**SB-GA8-2009-53**

**Issue 7**

# Service Bulletin

Undercarriage Access Panel Retrofit

**Figure 1:** Rivets to be removed from belly (only the inside rows of rivets of the double rows shown).

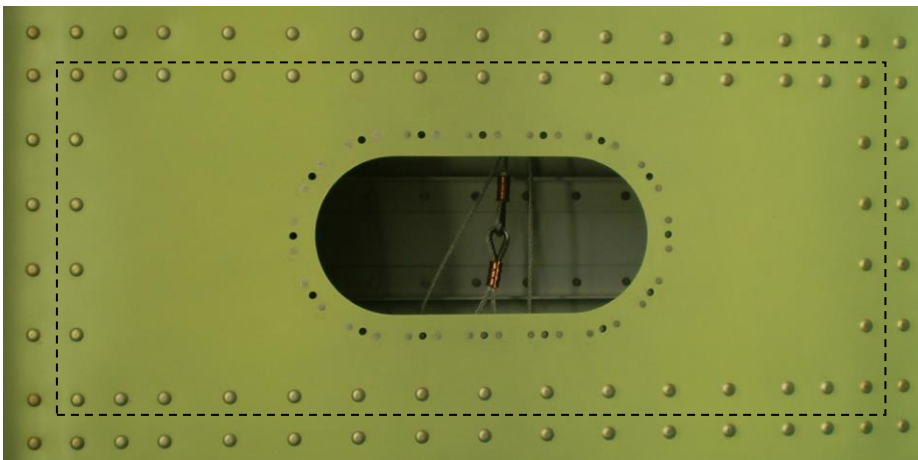
1. Jack aircraft as required.
2. Drill out and remove the domed head rivets within the dotted boundary shown in Figure 1 in the belly surrounding the existing undercarriage access panel.

**Figure 2: Drill-off template detail.**

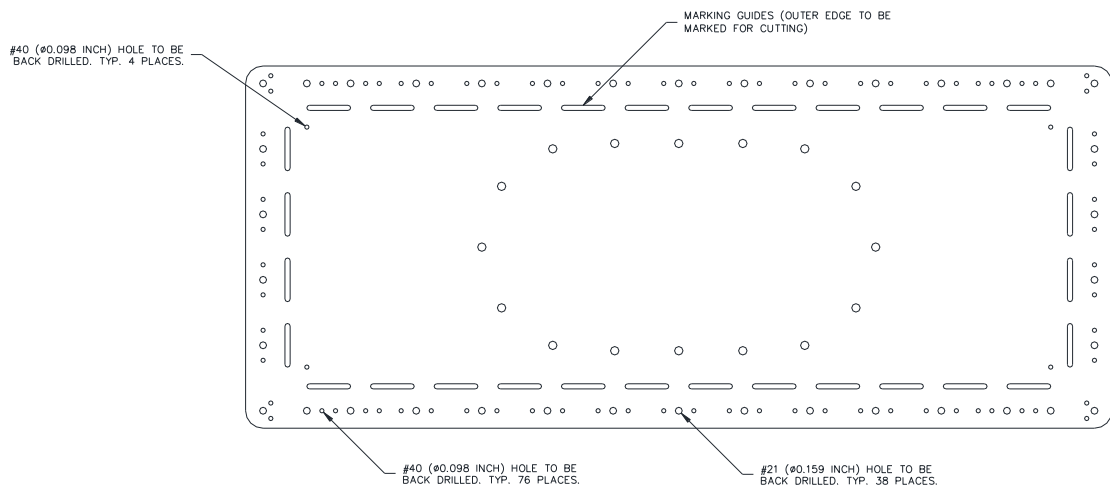
3. If the existing access panel is secured, unscrew and remove it.
4. Using the same screws for securing the existing access panel, secure drill-off template (P/N GA8-945321-021) to the belly in place of the existing access panel. Refer to Figure 2.

5. Drill the #21 (0.159 inch diameter) and #40 (0.098 inch diameter) anchor nut holes around the edge of the drill-off template, further securing the template as required by pinning it to the belly as holes are drilled.

6. Drill the four #40 (0.098 inch diameter) holes inside the corners of the marking guides of the drill-off template.
7. Mark the the new access hole using the marking guides in the drill-off template. The outside edges of the inch-long slots are the edges to be marked.

**Figure 1:** Hardware to be installed on belly skins

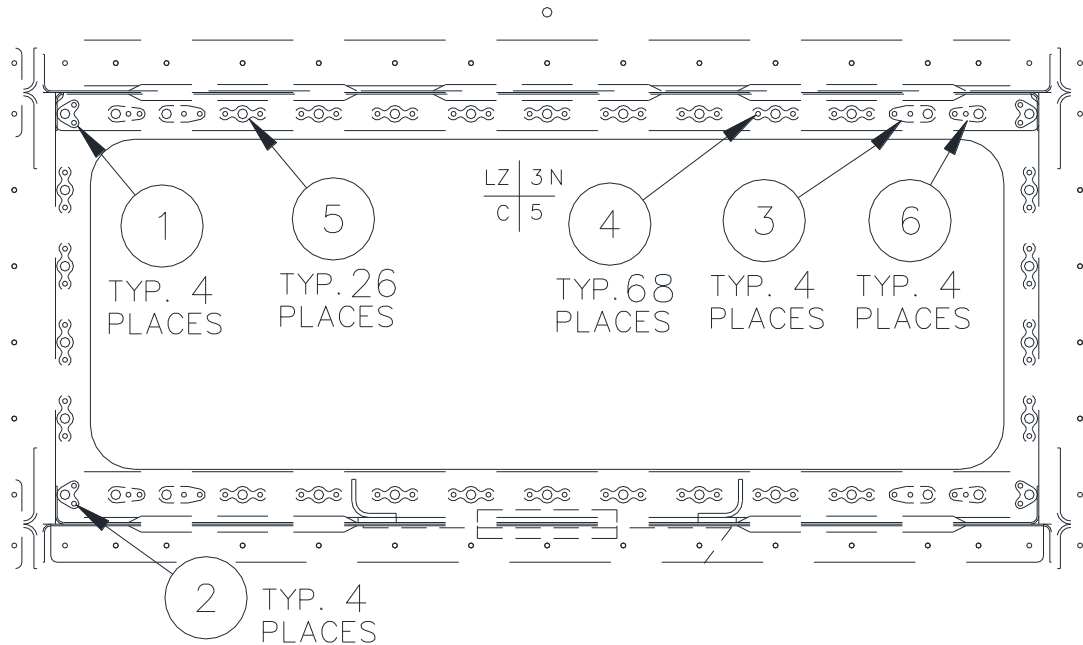
1. Jack aircraft as required.
2. Remove the existing mid cabin belly skin (P/N GA8-533021-25) and fwd cabin belly skin (P/N GA8-533021-13) surrounding the existing undercarriage access panel and replace it with GA8-533021-115 (mid cabin belly skin) and GA8-533021-113 (fwd cabin belly skin).

3. Install four MS21073L3 corner leg anchor nut in each corner using MS20426AD3-6 rivets.
4. Install four MS21051-L3 one leg anchor nuts inboard of each corner leg anchor nut using NAS1097AD3-5 rivets.
5. Install MS21047-L3 anchor nuts and MS21071-L3 one leg anchor nut in remaining locations using NAS1097AD3-5 rivets.
6. Install placard (P/N GA8-112011-401) onto the inside face of the new access panel (P/N GA8-533021-129).
7. Install the new access panel using AN525-10R8 screws.
